MARKED UP BASES & TECH SPEC PAGES

TECHNICAL JUSTIFICATION

Pursuant to 10CFR 50.4 and 50.90, attached are proposed license amendments to Appendix A, Technical Specifications, of Facility Operating Licenses NPF-9 and NPF-17 for McGuire Nuclear Station Units 1 and 2, respectively. The proposed amendments are a one-time only change necessary to allow replacement of the existing 125 volt DC battery cells with new cells. This replacement will result in a net enhancement in safety at McGuire Nuclear Station due to increasing the reliability of the 125 Volt DC Vital Instrumentation and Control Power System.

FIGURE 1

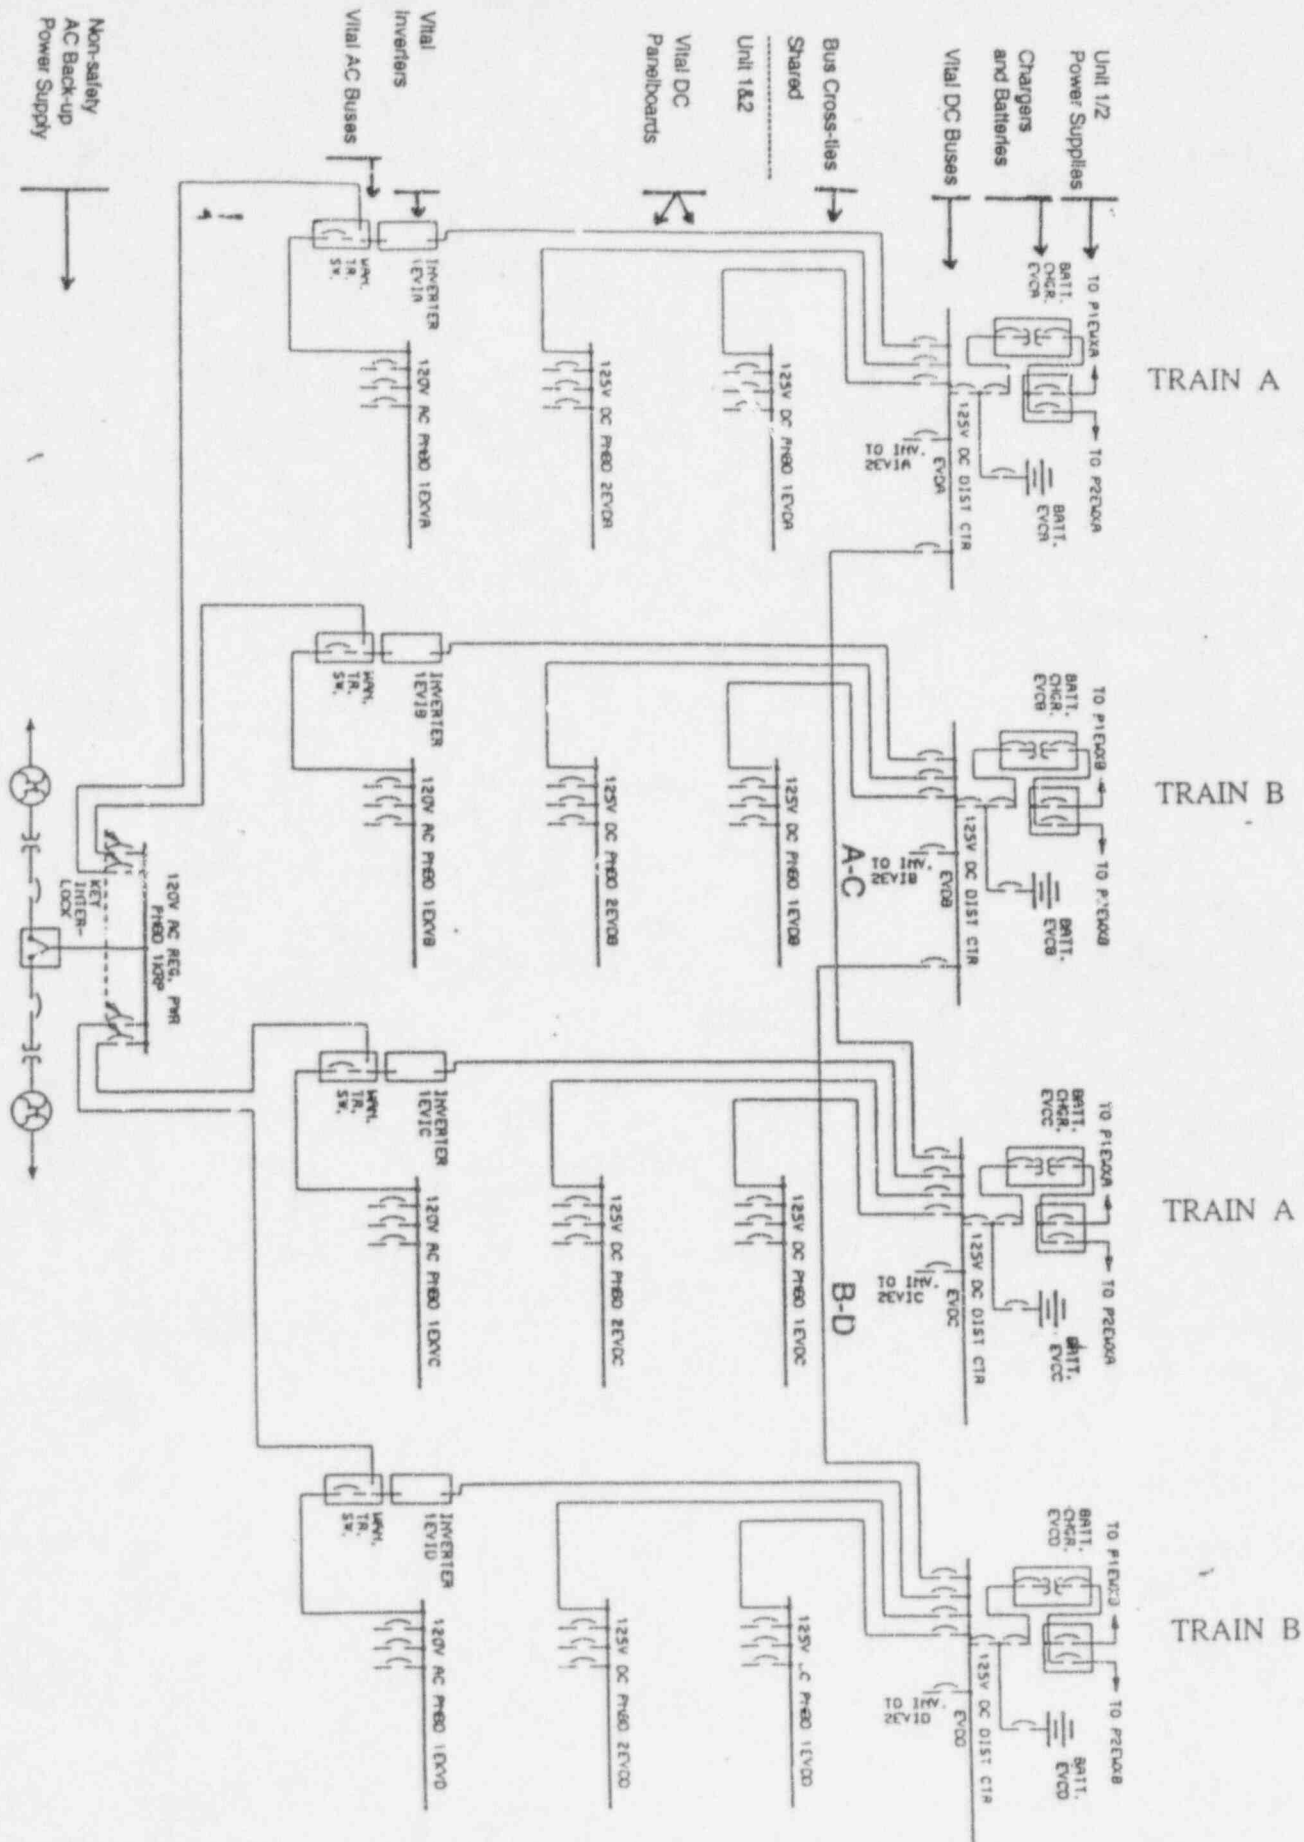
The design of the 125 VDC I & C power system (see Figure 1) is such that four batteries, chargers and distribution centers serve both units. Each of the four batteries and chargers are connected through their own respective distribution center which is shared by both Units 1 and 2. The loads served from these distribution centers are unitized, providing a 125 VDC power panelboard and inverter for each unit. The distribution centers are designed to provide cross-tie capability with its "associated" distribution center of the same train (load group).

When the ACTION statement of Technical Specification 3.8.2.1.b.2 is invoked via OPERABLE tie breakers, and one battery and charger is removed from its bus, the distribution center (of the removed battery) and its normal loads are still energized by a full capacity charger and battery of the same affected train. For this alignment, one battery is serving two buses on one train. On the other train, two batteries are serving two buses, while assuring train redundancy at all times. All four batteries, including the one serving two buses during the Allowable Outage Time (AOT), are sized to serve normal and emergency loads of both buses. They independently have the capacity to automatically supply minimum engineered safety feature DC loads for accident conditions in one unit and safely shut down the other unit assuming both a loss of offsite power and a single failure in the 125 VDC system.

Figure 2 - AT&T LINEAGE 2000 Round Cell Battery (Cutaway View)

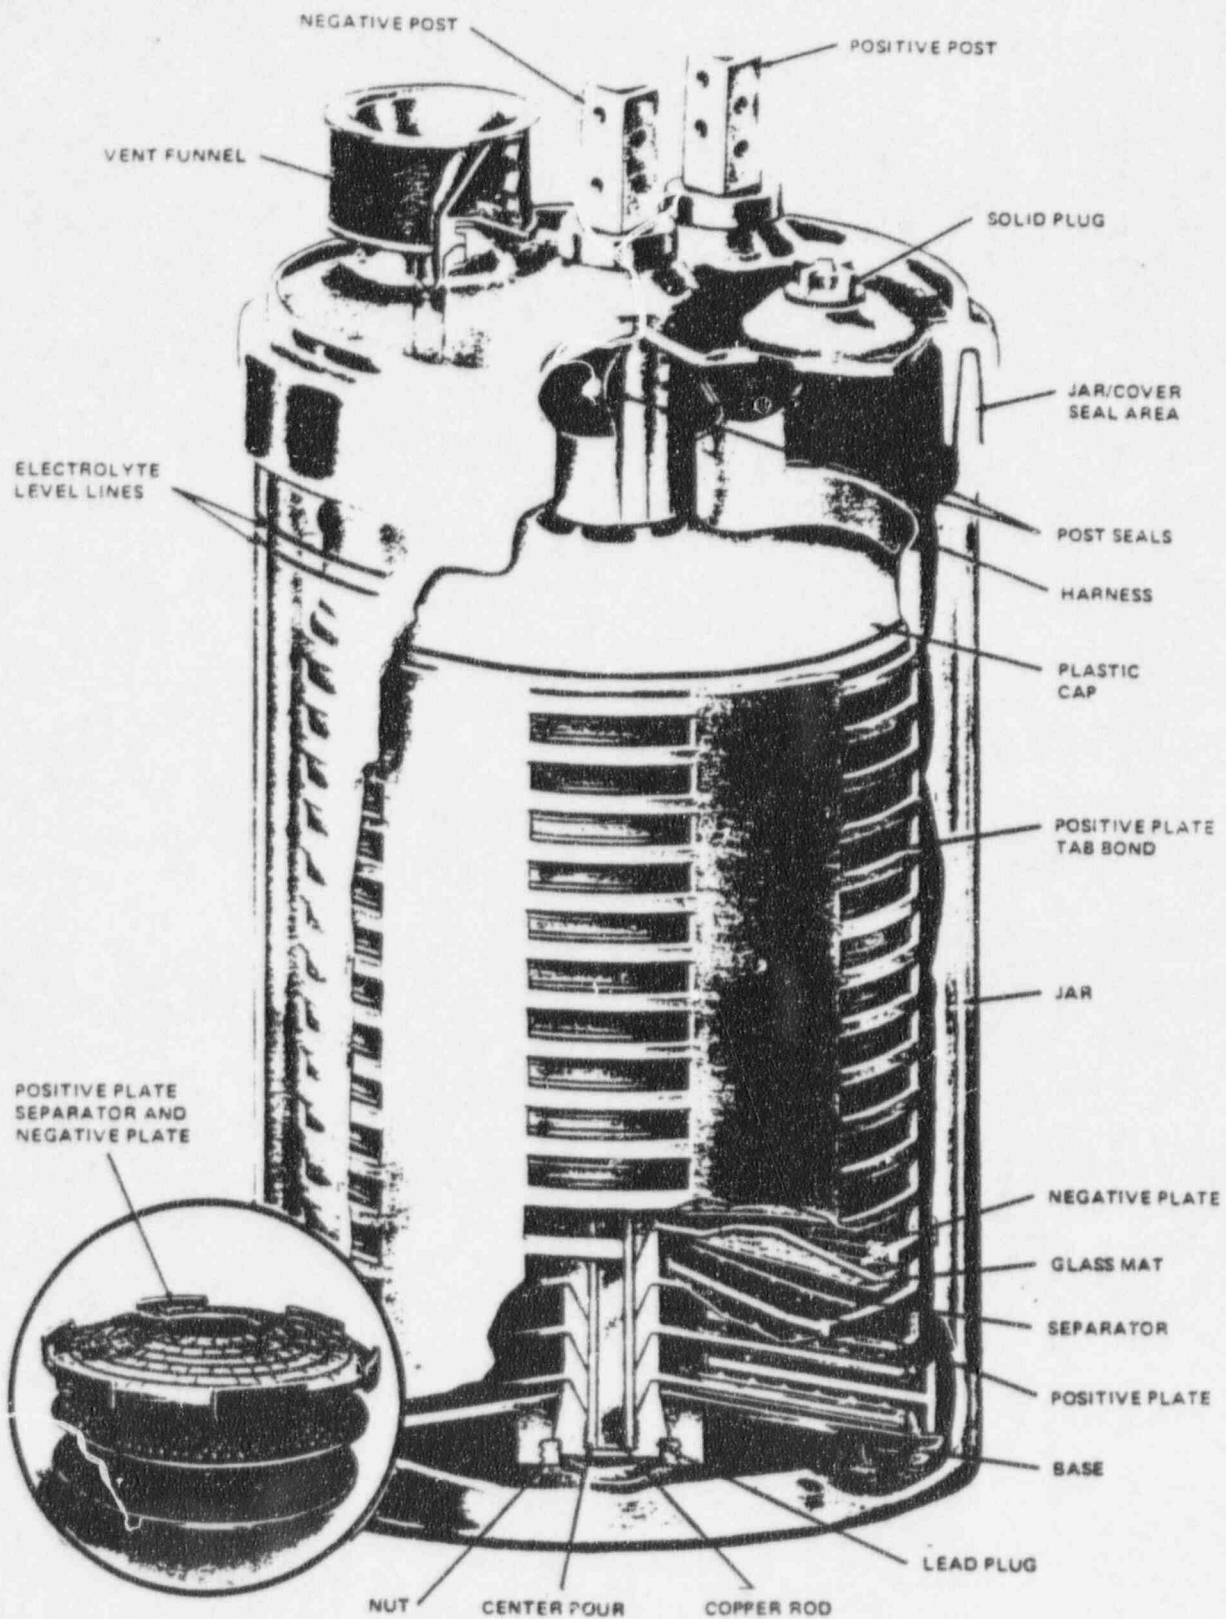
The battery selected for replacement is the AT&T LINEAGE 2000 Round Cell Battery. This battery (see Figure 2) is a secondary, lead-acid, flooded cell designed by AT&T Bell Laboratories. The specific size (model) selected for McGuire is Model KS-20472, List 1SH (1850 Ampere Hours). Table 1 below lists characteristics of the replacement batteries.
